Staff Comments Regarding Files:

A43/08, A49/08, B01/09 & A1/09, B2/09, B3/09, A2/09, A3/09 and A4/09

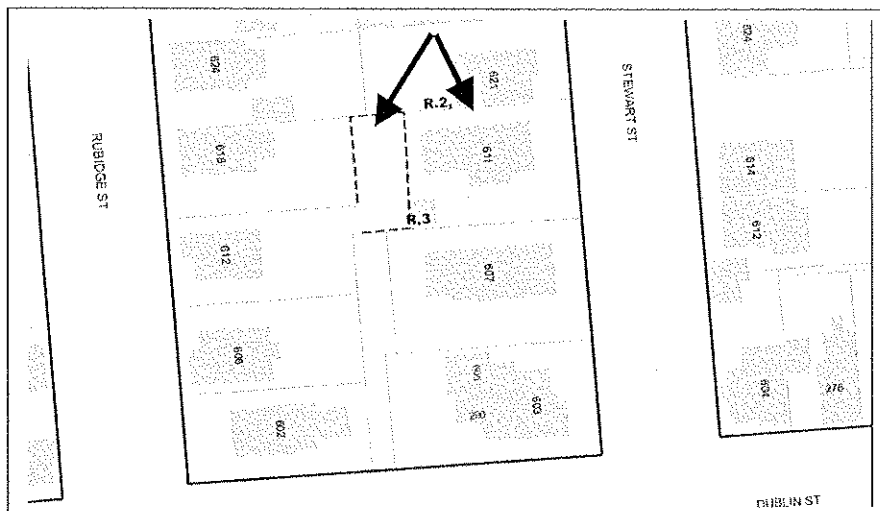
Referring to the property map below, the owner of 612 Rubidge Street would like to convey the easterly 9 metres of the subject property to the owner of the adjacent property known municipally as 611 Stewart Street.

Addition of the easterly 9 metres of 612 Rubidge Street to the rear of 611 Stewart Street.

The portion of property is surplus to the requirements of 612 Rubidge Street and would improve the practical configuration of the two properties improving the conformity of 611 Stewart Street.

Staff considered the proposal and would concur that the conveyance would contribute to improving the logical and legal configuration of two properties. Subject to concerns raised by neighbouring property owners, Staff would support the conveyance of the property subject to the provision of a survey to the satisfaction of the City Planner.

File A03/09

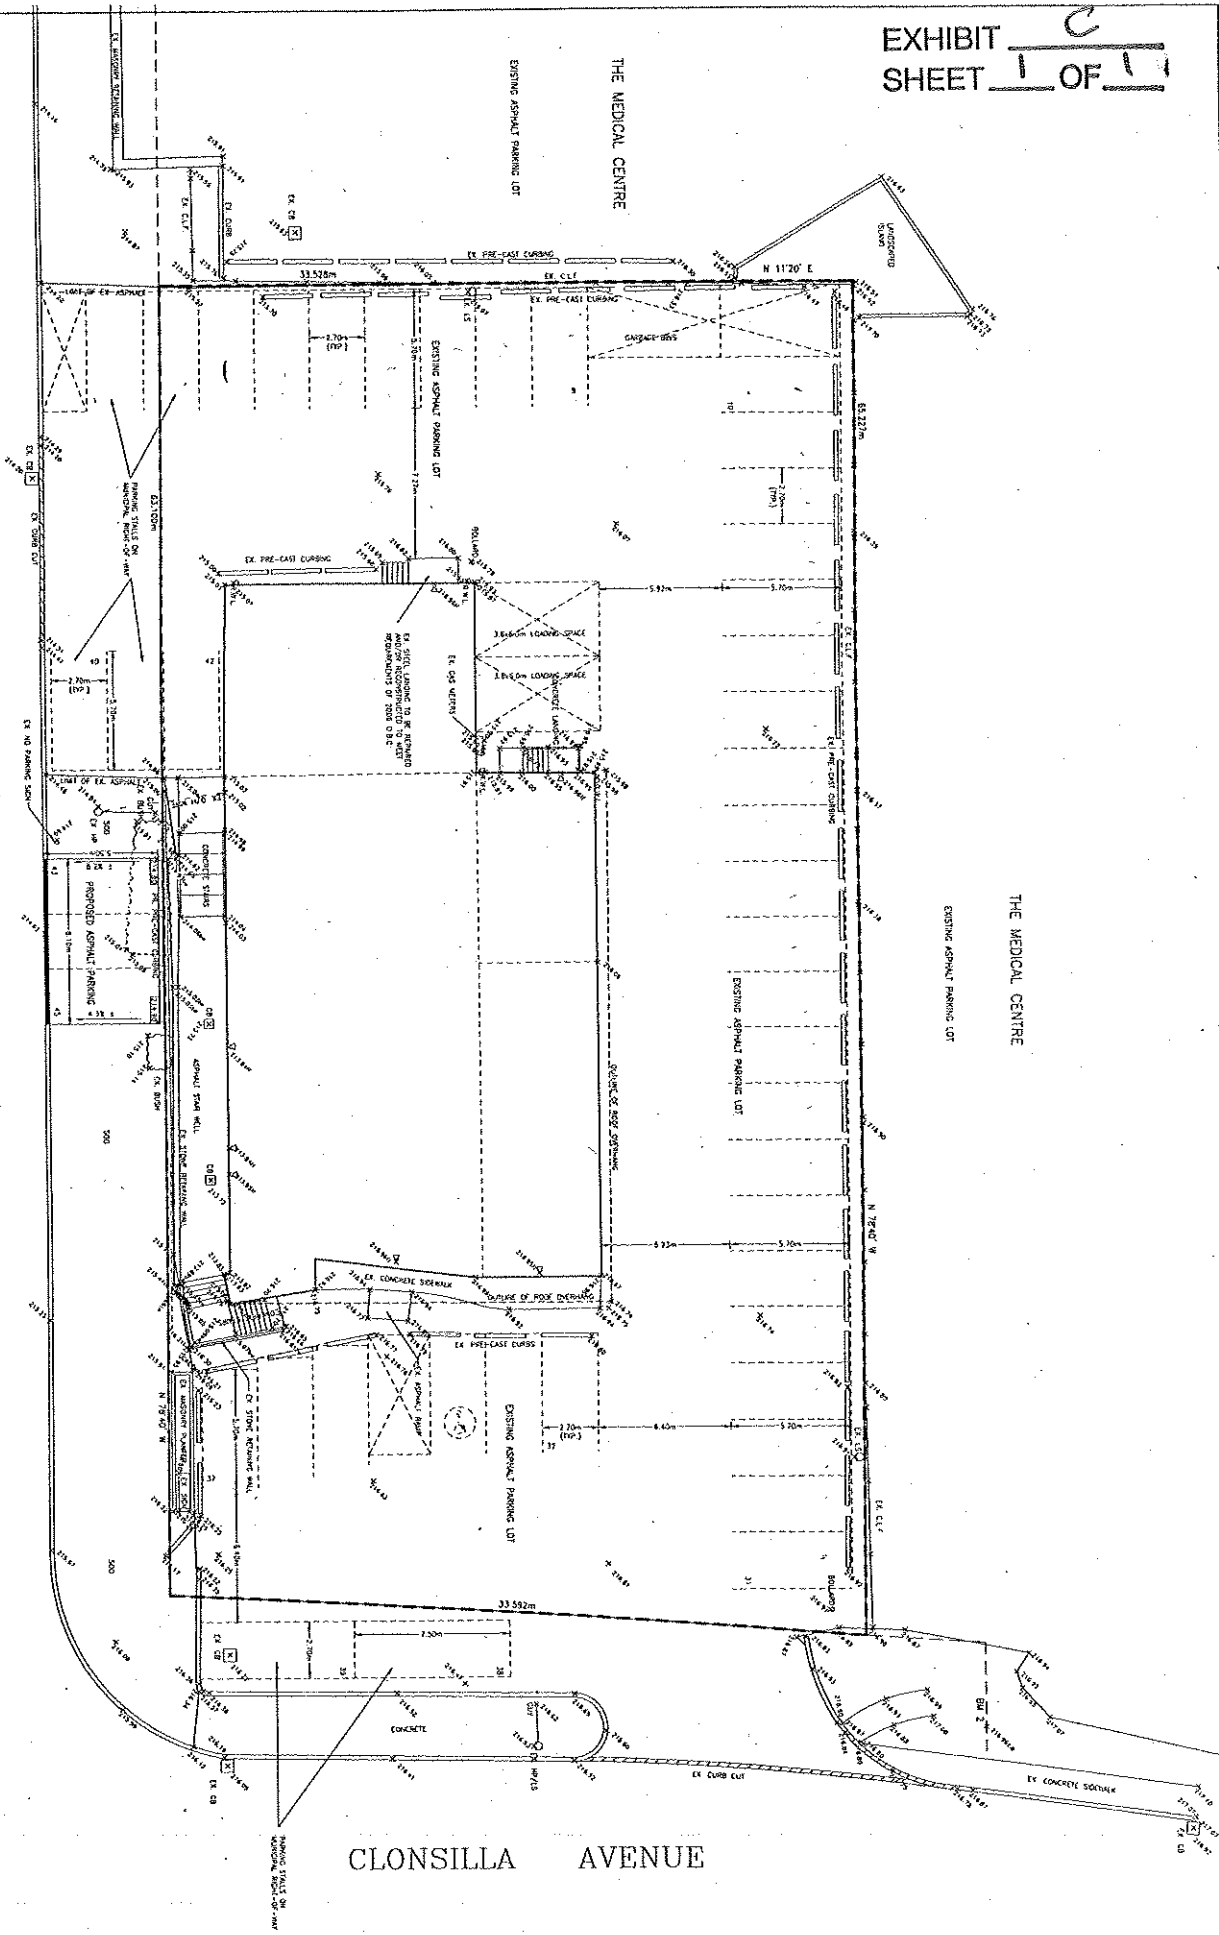
The owner would like to expand the area within the existing building that is used for a drug store. A variance is therefore requested to increase the maximum floor area per commercial purpose permitted by the zoning district from 140 square metres (1506 sq ft) to 348 square metres (3745 sq ft).

The parking was available on the property and it appears to have functioned since 1985. The C.1 Commercial Zoning district permits a drug store, which from a parking assessment standpoint, operates similar to the convenience store. Considering that there is adequate parking on site and that convenience store will be giving way to the drug store as the principal use of the property Staff is of the opinion that the impact of the variance sought would not be significant.

Subject to concerns raised by neighbouring property owners Staff would not object to the Committee granting the variance as described provided that on site parking is provided in accordance with the by-law considering other uses within the building.
